LEE'S SUMMIT
MISSOURI
Development Services Department

Development Services Staff Report

File Number	PL2024-157
File Name	REZONING from R-1 to PMIX – Discovery Crossing, Lots 1-9
Applicant	Intrinsic Development, LLC, applicant
Property Address	1810 NE Douglas St and 101 NW Colbern Rd
Planning Commission Date Heard by	September 12, 2024 Planning Commission and City Council
Analyst	Hector Soto, Jr., AICP, Senior Planner

Figure 1 - Site Plan

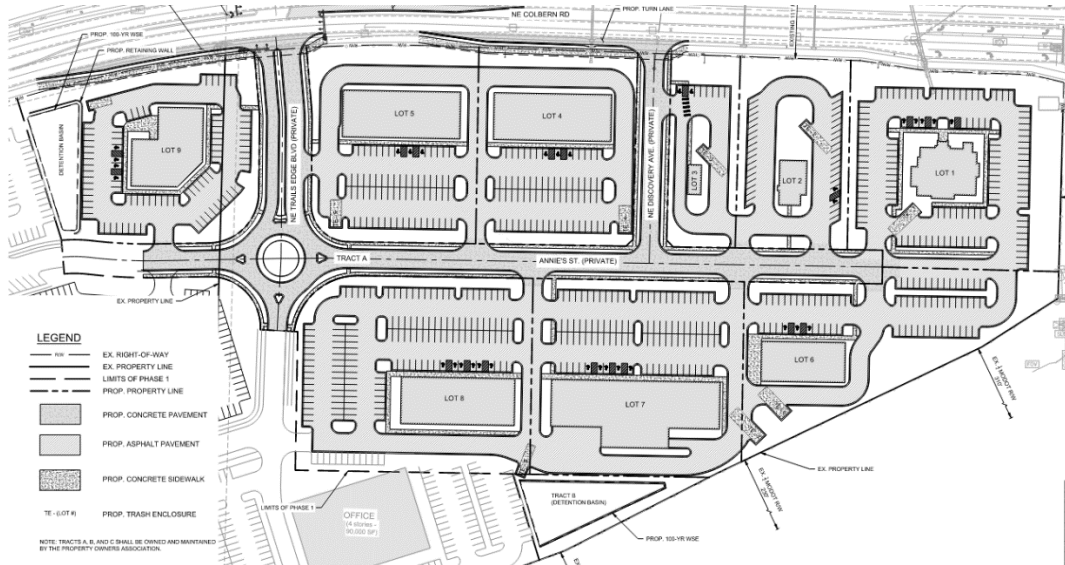
The buildings on Lots 7 and 8 exceed 300 feet to a hydrant measured from the most exterior portion of the building.

The distance to a hydrant exceeds 100 feet on Lots: 1,2,3,4,5,6,7,8 and 9.

The building on Lot 9 does not meet the requirement. Provide hydrants or adjust spacing to meet requirements. Provide hydrants along the north side of NE Colbern Road.

Figure 7 - Proposed reduced parking lot setback area.

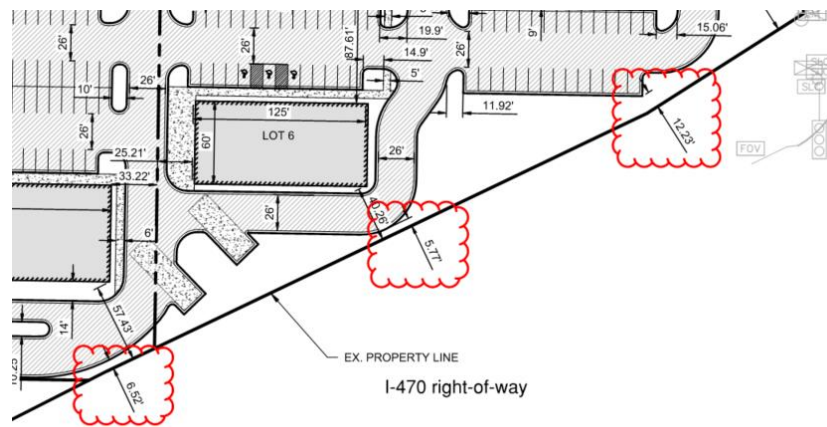
The applicant is seeking a modification to UDO Section 8.620 pertaining to the required 20' parking lot setback. Staff has reviewed the request and supports the requested modification for the reasons identified below.

- Required – minimum 20' setback from the right-of-way
- Proposed – 5.77' setback from the I-470 right-of-way
- Recommended – The area with proposed reduced parking lot setbacks are along the westbound I-470 on-ramp where there is an abundance of right-of-way width that provides ample separation between the parking lot boundaries and the on-ramp lanes travel lanes. More specifically, the parking lot boundaries will maintain between approximately 60' (on the east end of the development) and 100' (near the mid-point of the development) of separation to the abutting I-470 on-ramp, compared to approximately 35' of separation between a parking lot boundary and the nearest edge of street pavement along a typical collector or arterial street. The proposed parking lot with reduced setbacks along the south project boundary will maintain greater separation from the adjacent on-ramp travel lanes than a typical commercial site. Staff supports the modification request.

1. A modification shall be granted to the minimum 20' parking lot setback from the right-of-way, to allow a minimum 5.77' parking lot setback along the I-470 right-of-way.
2. Development shall be in accordance with the preliminary development plan with a revision date of July 26, 2024; landscape plan with a revision date of July 30, 2024; architectural renderings uploaded June 20, 2024; and design guidelines prepared by the developer uploaded June 20, 2024.
3. The development standards (e.g. setbacks, building heights, lot sizes, etc.) and range of allowable land uses that will govern the subject PMIX development shall be the established development standards and allowable land uses of the CP-2 zoning district.
4. Development shall be in accordance with the recommended road improvements included in the TIA dated, August 28, 2024, prepared by Erin Ralovo, P.E., Senior Staff Engineer.
